**Staff Report: Century Technology Campus
Preliminary Plan Amendment 12002095A
Site Plan Amendment 82003007A**

DATE: December 17, 2009

Creation of one recorded parcel for a total of 510,702 gross square feet of general office use and 21,000 square feet of accessory storage uses, on approximately 51.8 acres in the I-3 Zone; located on Century Boulevard, at the intersection of Cloverleaf Center Drive, in the Germantown Master Plan area.

Conceptual Site Master Plan

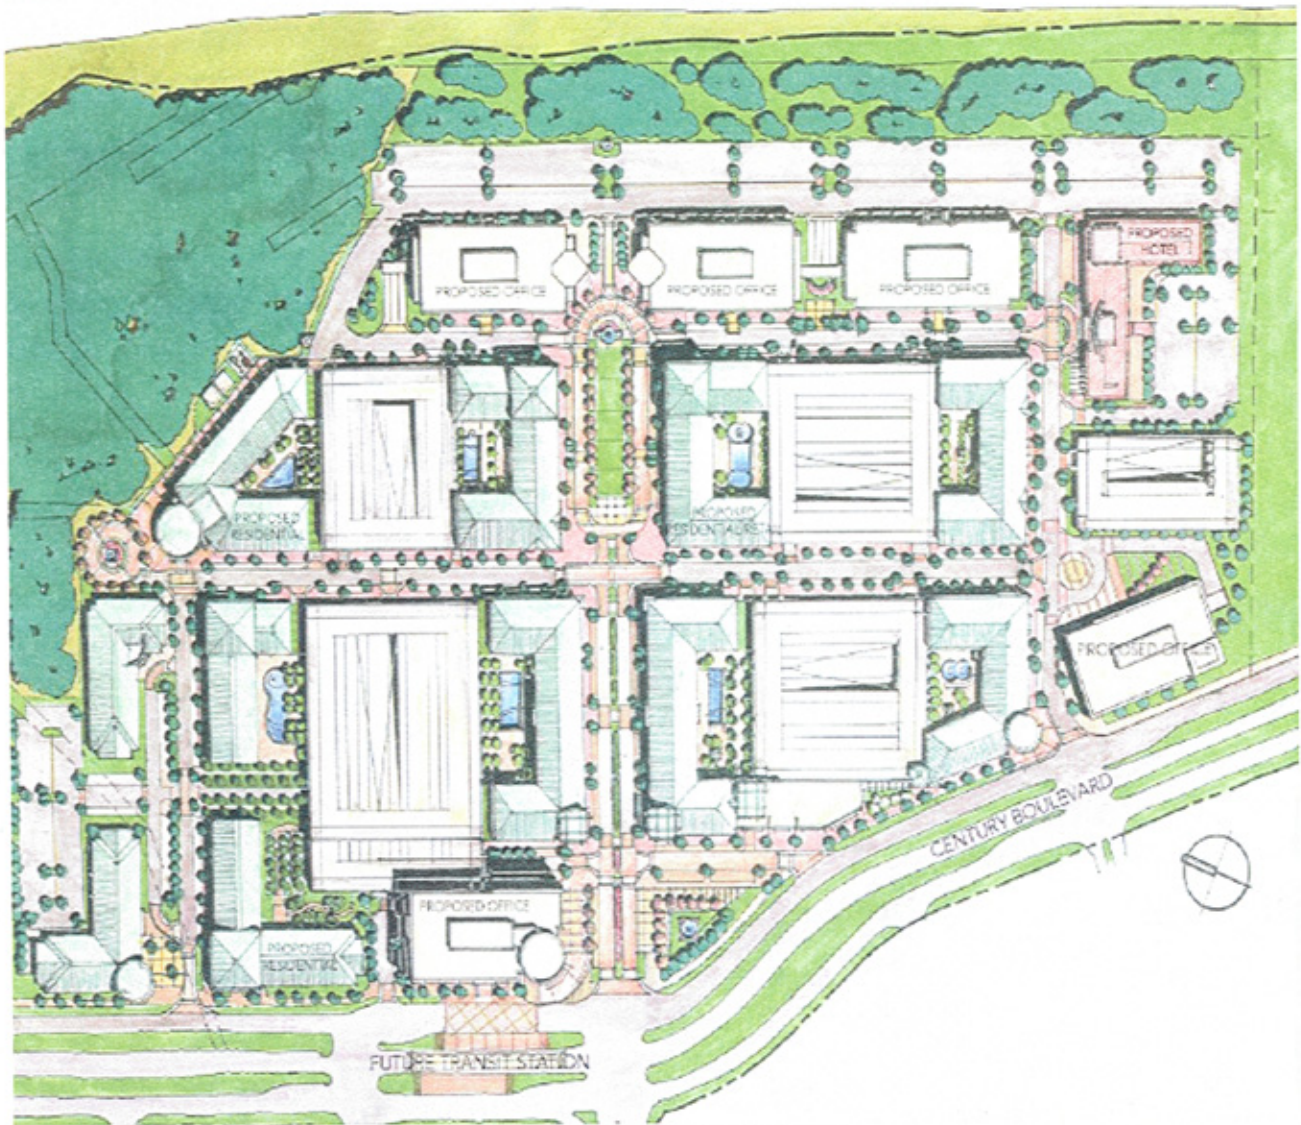
The route for the Corridor Cities Transitway (CCT) public transit system is expected to run along Century Boulevard in front of the site en route to the nearby Germantown Transit Center. There is also an 80' wide strip on the southern property line where the CCT is expected to cross I-270. The recently approved Sector Plan for the Germantown Employment Area calls for a 134-foot right-of-way to accommodate the CCT within a 50-foot median and two travel lanes on either side of the transitway. The proposed plans currently delineate a 130-foot dedication and Staff is recommending a condition requiring four additional feet of dedication. The 80' wide strip on the southern property line is to be placed in reservation for future acquisition for additional right-of-way. The reservation period is limited to the maximum three years provided under the Subdivision Regulations, however, it is probably unlikely that the right-of-way will be acquired within this period. If it is not, staff will explore other mechanisms for longer term protection of this important CCT link as part of future phases of development on this property.

Although this proposal complies with the development standards of the current I-3 zoning, the specific proposal before the Board seems to fall far short of the design and planning objectives of the recently approved and adopted Sector Plan for the Germantown Employment Area. . In fact, however, Staff and the Applicant spent considerable time ensuring that the basic framework of the future vision – of both the Sector Plan and the site itself – was being put in place in an efficient and effective manner. This application is only the first phase of the intended development, and looking more holistically at the Applicant’s final master plan for the site, the proposal fits well into the mixed-use, urban street grid envisioned for this area. This first phase was done in such a way as to allow future growth to fill in around these buildings and along the street grid as it develops with concurrent economic growth and transit options. In the meantime, however, Staff and the Applicant have worked to ensure that the interim development will be attractive and compatible with the surrounding area.

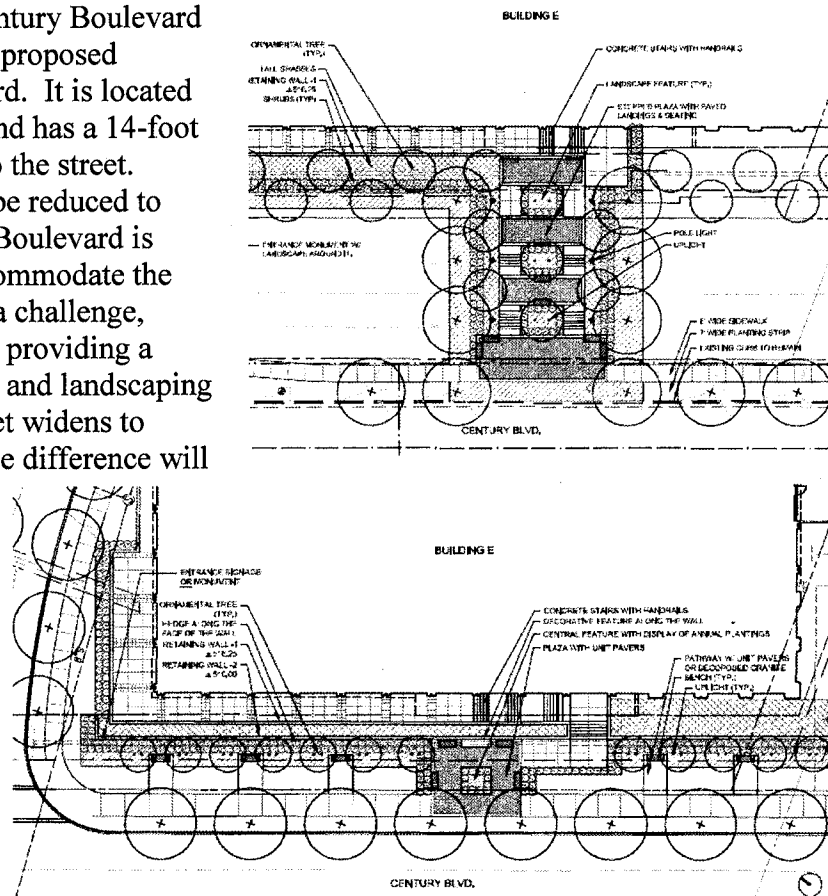
In Phase 1, the subject of this application, achieving street-oriented development along Century Boulevard is a challenge. Building E is the only proposed building adjacent to Century Boulevard. It is located 95 feet from the existing street curb and has a 14-foot grade difference from the first floor to the street. Ultimately, the building setback will be reduced to approximately 30 feet when Century Boulevard is expanded to its 134-foot width to accommodate the CCT. The grade difference remains a challenge, which the proposed plan addresses by providing a series of stepped terraces with seating and landscaping for the interim period. When the street widens to accommodate the transitway, the grade difference will be accommodated with a narrower plaza providing access to the building from Century Boulevard. Given that Building E is located some distance from the center of the Cloverleaf District and is not planned for first floor activating uses, the proposed grade relationship to the street is acceptable.

The street oriented, urban character envisioned by the Sector Plan will be compromised in future phases by the proposed public utility easement (PUE) along Century Boulevard's right-of-way that will force buildings to be set back further from the curb and restrict what can be built in the easement. Within the central business districts, there are no PUE's and buildings are located behind the right-of-way without additional setback restrictions caused by the PUE. Utilities typically located in a PUE are located under the public sidewalk or to the rear of buildings in urban areas. The Town Center and the Cloverleaf District are designated by the Sector Plan as urban areas to enable use of the Road Code's urban street standards. This urban standard should also be applied to the PUE in this area. It is conditioned that the PUE along Century Boulevard must be provided unless an agreement between staff, MCDOT and the applicable utility companies can be reached during the certified site plan review to allow utilities to be placed within the right-of-way or along internal streets and behind buildings.

The proposed landscape plans need to be updated to reflect the most recent street layout revisions requested by Planning Department Staff. All streets need to be lined with street trees, pedestrian lighting and sidewalks set back behind the tree line. The view of the large, central parking lot will need to be adequately screened from views along Century Boulevard in the interim stage. This area between the central parking lot and Century Boulevard will ultimately be redeveloped but the interim view needs to be landscaped.

Along the I-270 right-of-way, all parking should be further screened from view with additional plantings along the highway. The plans show stormwater management basins in some locations that will prevent adequate screening of the parking. In these areas, landscaping to screen parking should be provided within the I-270 right-of-way and approved by the State Highway Administration.

- a. Revise streetscape treatment along internal streets to match modified layout shown on submitted site plans.
- b. Provide shade trees at regular intervals along all internal sidewalks from Century Boulevard to the existing and proposed building.

- c. Provide continuous sidewalk connections along the entrance drive north of Cloverleaf Center Drive and around driveway entrances to parking lots.
- d. Show Building E's south entrance facing Century Boulevard on all drawings. Further define the south entrance with architectural elements that read more clearly as a building entrance along Century Boulevard.
